Re: Minor Project Refinement No. 4 for the TL 6975 San Marcos to Escondido Project.

TL6975 San Marcos to Escondido 69 kV Project CPUC Minor Project Refinement Form

Report No.: 4

ATTACHMENT B
MPR-4 Figure

**MPR-4 Figure 1
Structure Location 81
San Diego County, CA**

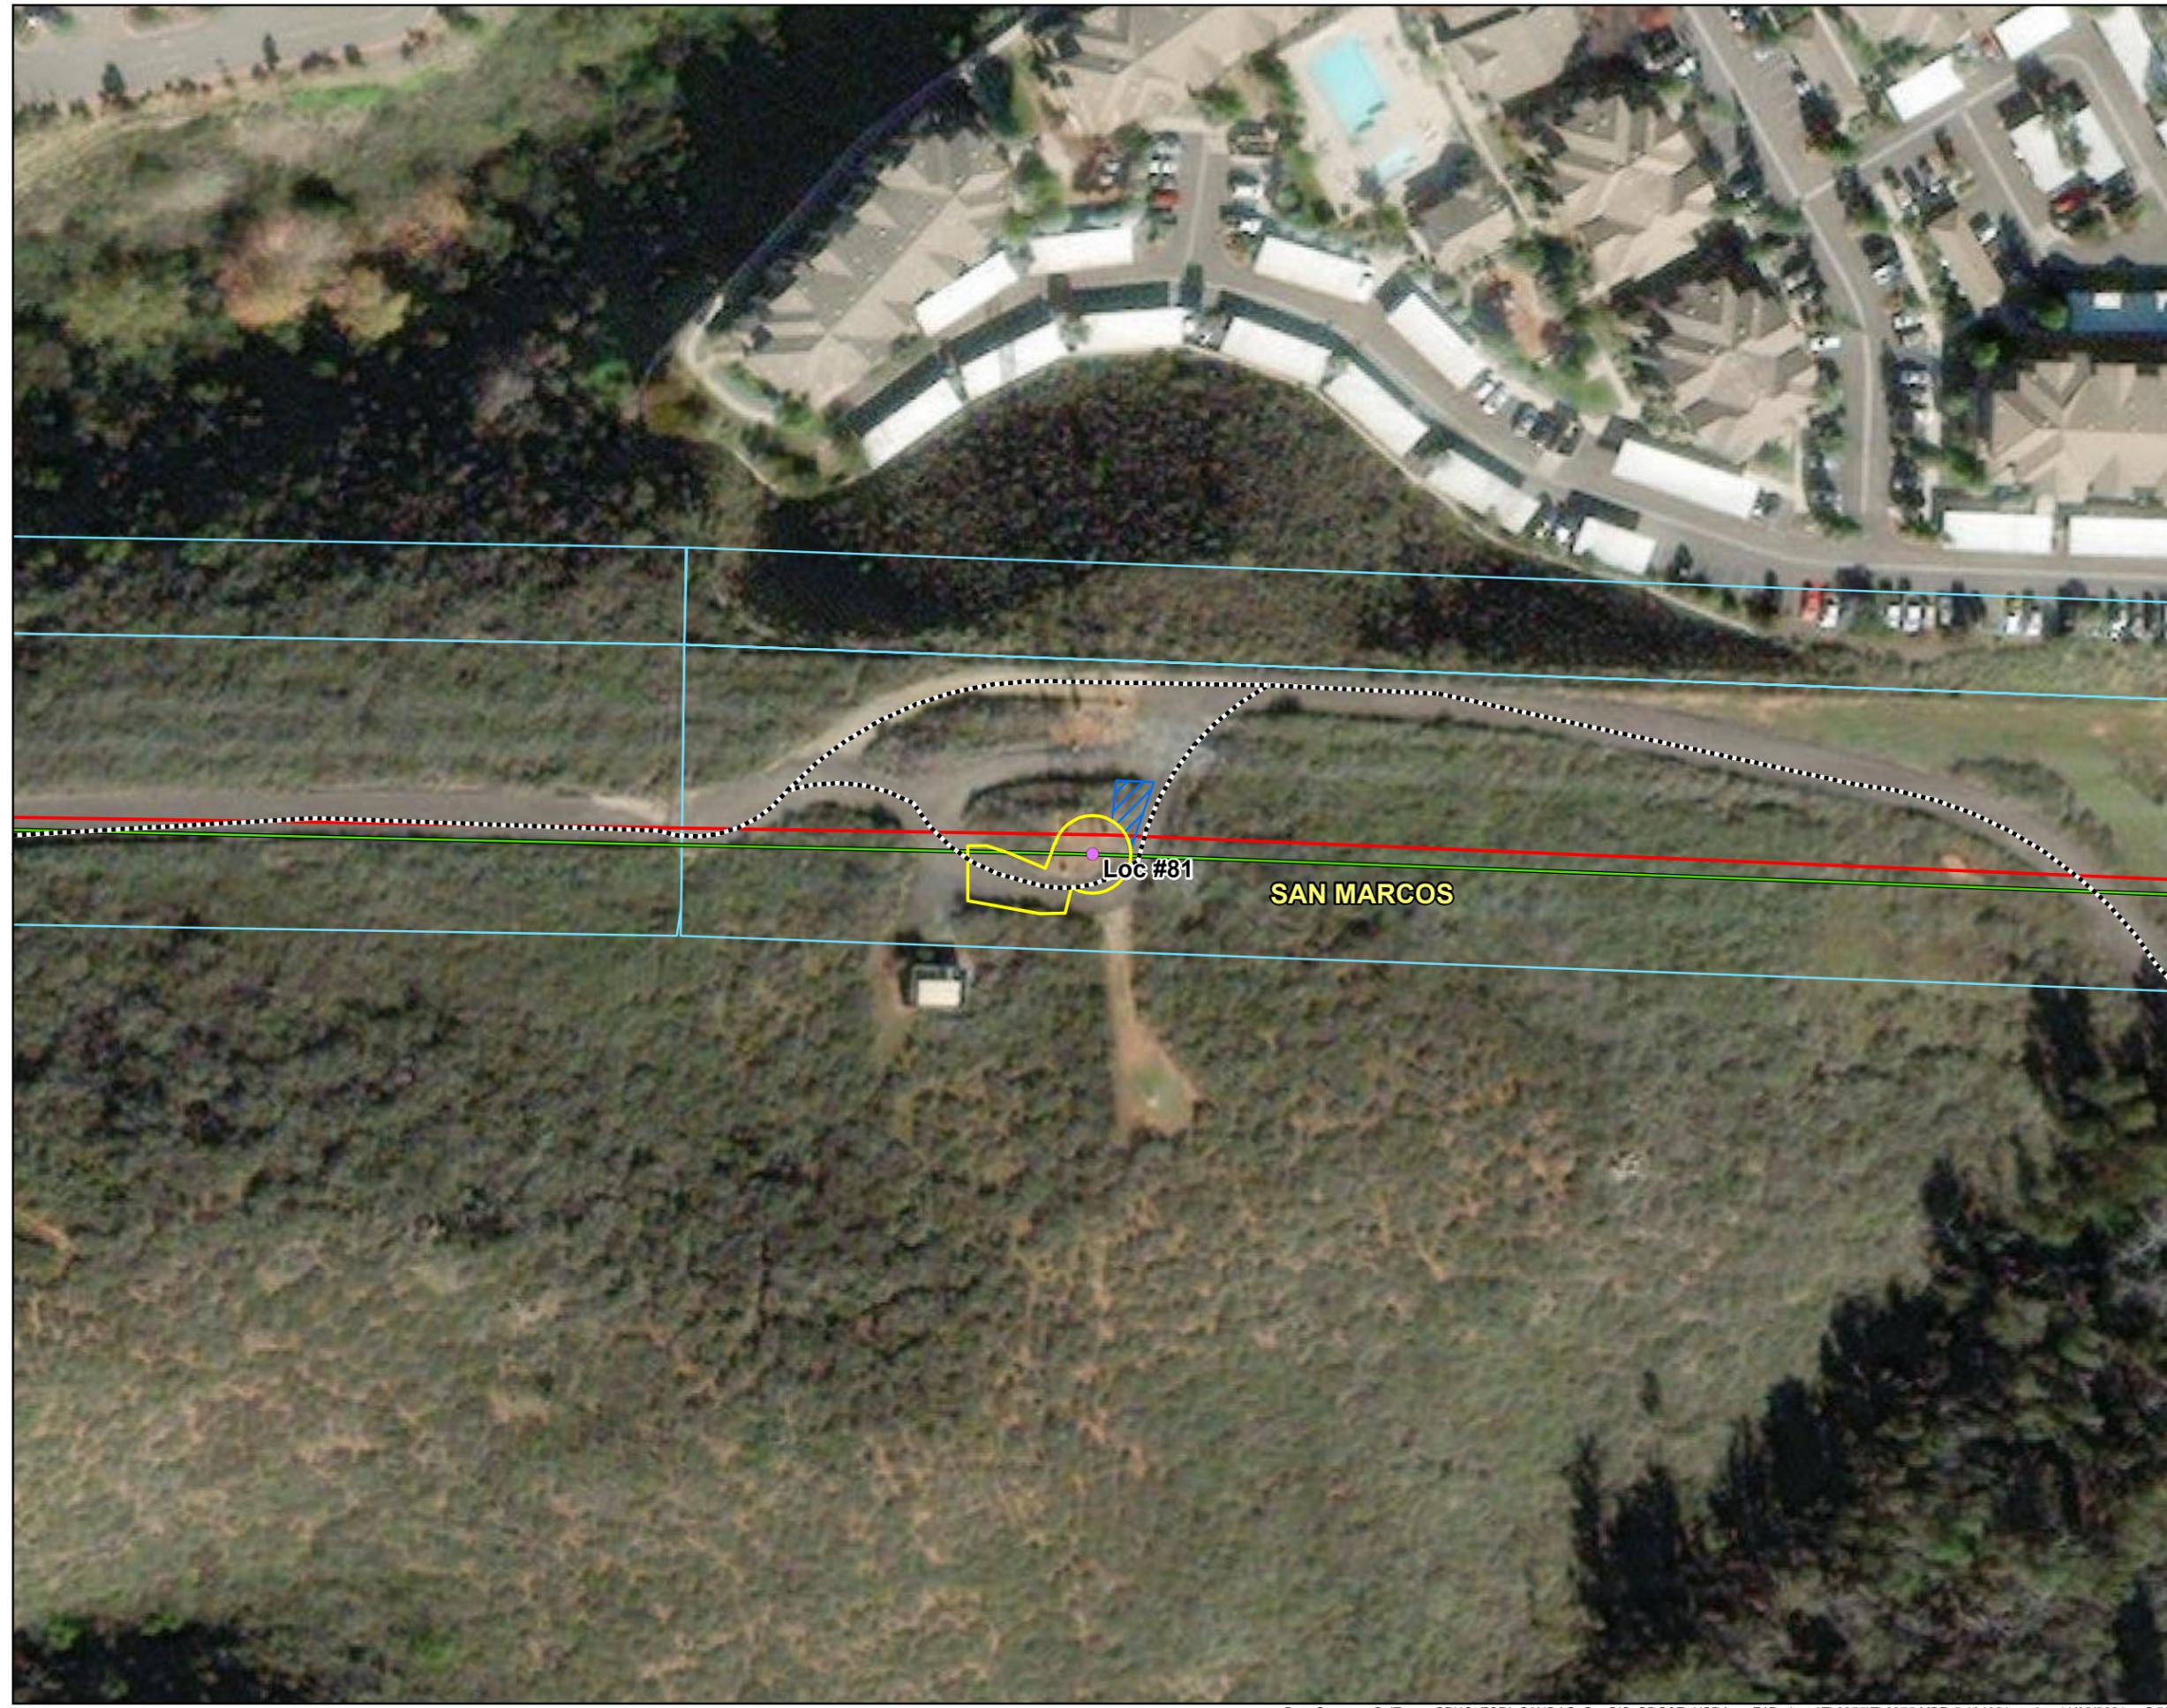
- **Location 81 Additional Work Area (WA 81):** The additional work area at Location 81 is being requested in order to allow the crane to set up on the northeast side of the tower rather than the southwest side of the tower where the approved work area is located. The crane cannot be set up underneath the energized lines on the southwest side of the tower, therefore this additional workspace will be needed to allow the crane to be set up to the northeast partially within the existing access road. This would require access to WA 81 and additional vegetation trimming within WA 81. The additional work area (WA 81) would be approximately 433 square feet (0.01 acre) in size.

Following the field constructability review, it was determined that the crane could not safely set up on the southwest side Location 81 under the existing energized overhead power lines, where the approved work area is located. Therefore, WA 81 is being proposed so that the crane can set up on the northeast side of Location 81. Setting from the northeast side of the tower would keep the crane away from the energized lines and provide a better angle for the overhead work.

**MPR-4 Figure 2
Structure Location 89
San Diego County, CA**

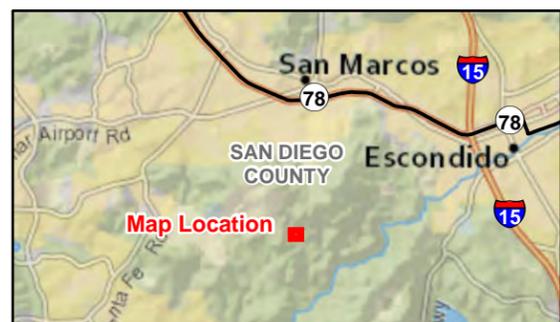
- **Location 89 Additional Work Area (WA 89):** The additional work area at Location 89 is being requested to extend the approved work area to allow for the deployment of outriggers to stabilize the crane. The crane can travel along the existing access road to the work area. However, once it reaches Location 89, additional workspace will be necessary to accommodate the approximately 24-foot-wide outriggers, and vegetation trimming would be required. The additional work area (WA 89) would be approximately 750 square feet (0.02 acre) in size.

Following the field constructability review, it was determined that the existing work area for Location 89 did not include sufficient space for the 24-foot-wide crane outriggers. The crane can travel along the existing access road up to the existing Location 89 work area without widening the access road, however, there is not enough space adjacent to the road to deploy the outriggers that stabilize the crane when it is carrying a load. Therefore, WA 89 is being requested to allow the space required for the outriggers.
